DOCUMENT NUMBER: FM-000-0004-48	TITLE: Form - Product Change Notice	
REVISION: H DCO# DC0005391	DOCUMENT CLASSIFICATION: 04-Forms, Templates or Other

PCN Number: PCN48801302-0001 **Revision:** A **Creation Date:** 31 Oct 2023

Description and Reason for Change:

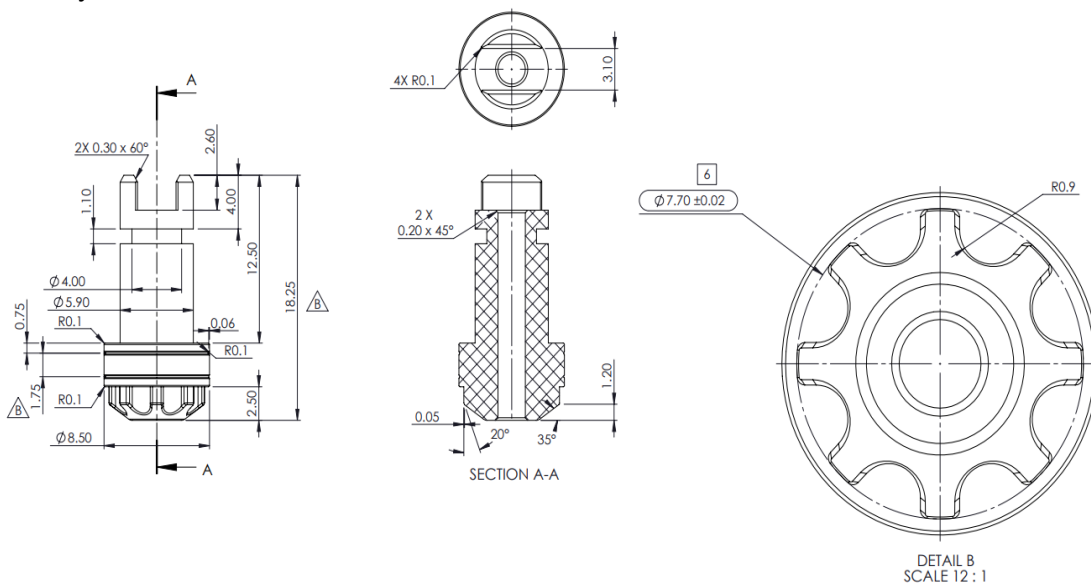
We are writing to inform you that as part of our proactive sustaining engineering program and to improve the performance delivered by IntelliXcap™ Automated Screw Cap Decapper/Recapper 96-format when working with *Azenta Life Sciences External Thread Screw caps* tubes, we are redesigning the cap drivers on the corresponding cartridge.

The new cap driver has been designed to improve engagement with the caps. Please see below, for information only, the new design of the affected part, with the new dimensions and geometry:
